Title: 2021 05 SPRING RETURN UNITS

Introduction.

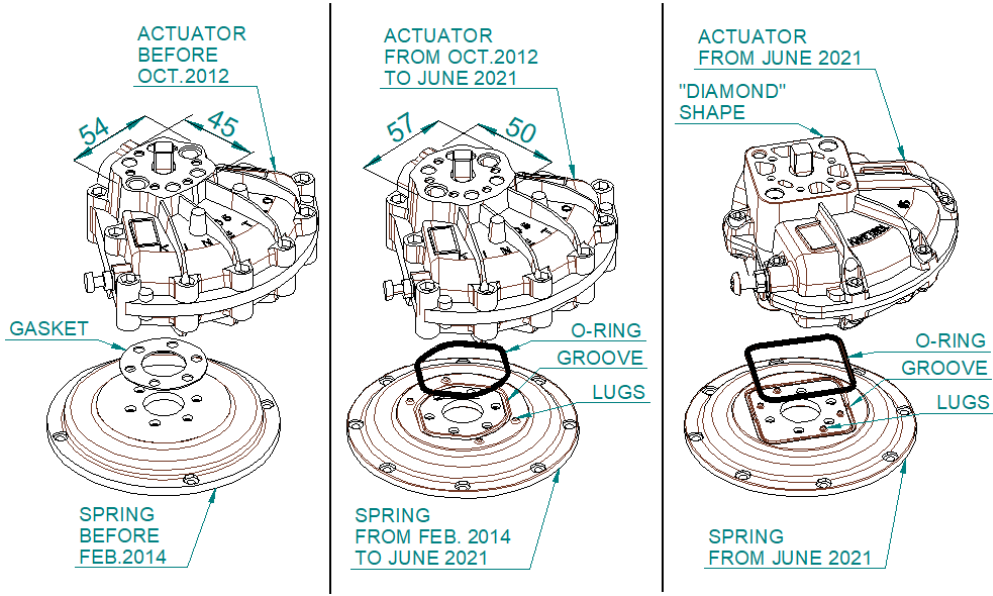
In June 2021 the 05 actuator was redesigned. This includes a change to the O-ring and groove in the spring unit base plate. This supersedes the redesign of 2014 sketches below show which base plate design is compatible with the relevant age of actuator.

Because of the shape of the O-ring groove, it is theoretically possible to fit the spring base plate to the actuator in the incorrect orientation (i.e. 60° out of position) which could allow leakage past the O-ring. To prevent this, the base plate has lugs protruding from the cast surface; If the base plate is attached to the actuator in the wrong orientation, the lugs will prevent the face of the base plate from contacting the actuator face, creating a clearly visible gap. The correct version of base plate must be used, and **MUST** be orientated such that the lugs overhang the sides of the actuator mounting face (2014 versions), or sit within the cast recesses (2021 versions) and do not make contact with the mounting face. (see sketch below)
